APPLICATION NO.	FILING DATE	FIRST NAMED INVENTOR	ATTORNEY DOCKET NO.	CONFIRMATION NO.
10/511,444	10/26/2004	Uwe Johann Riedel	W1.1879PCT-US	2494

<b>Office Action Summary</b>	Application No. 10/511,444	Applicant(s) RIEDEL, UWE JOHANN	
	Examiner Marissa L. Ferguson-Samreth	Art Unit 2854

## **DETAILED ACTION**

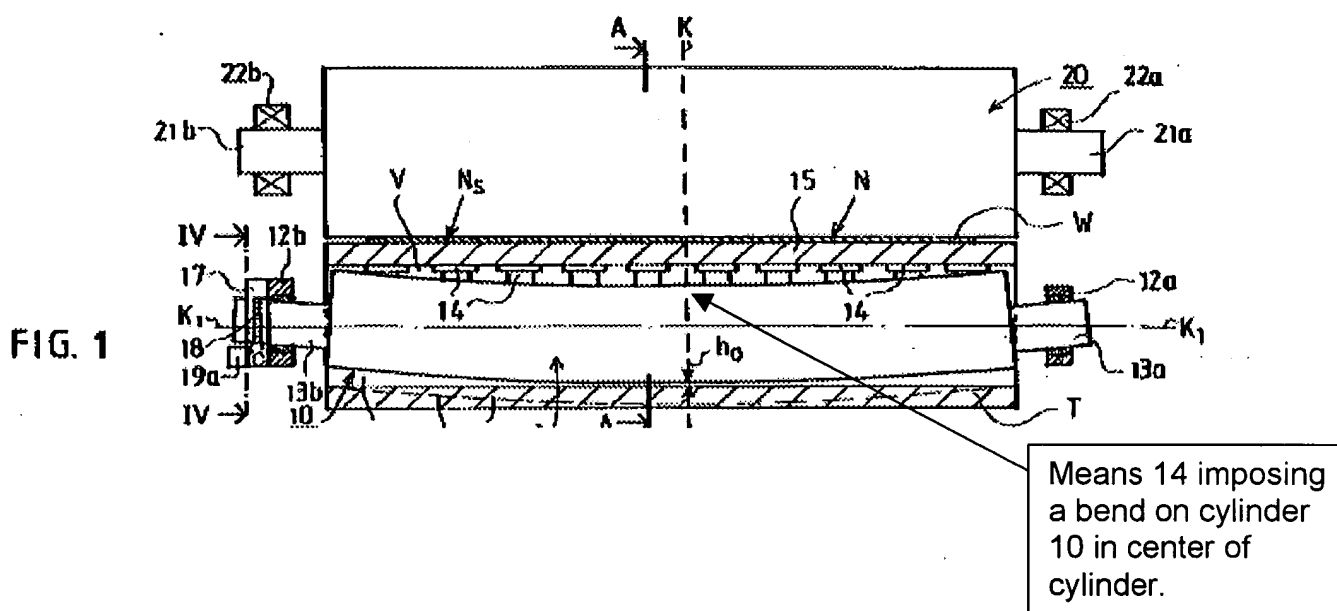
Regarding claim 31, Niskanen et al. teaches a means (13a, 13b) supporting the cylinder (10) for rotation in a web-travel direction about an axis of rotation and a means (14) imposing a bend on said cylinder in one of a direction in, and opposite to web travel direction (refer to figure 1 below).

Regarding claim 32, Niskanen et al. teaches wherein a cylinder bend is imposed on a center section of the cylinder in the web running direction (refer to figure 1 above).

Regarding claim 43, Niskanen et al. teaches wherein the bend (refer to figure 1 on page 4) is perpendicular to the web travel direction (W).

Regarding claim 40, Niskanen et al. teaches a plurality of actuating members (14) and wherein the actuating members shift the shaft end sections (13a, 13b) in first and second directions (Figure 1).
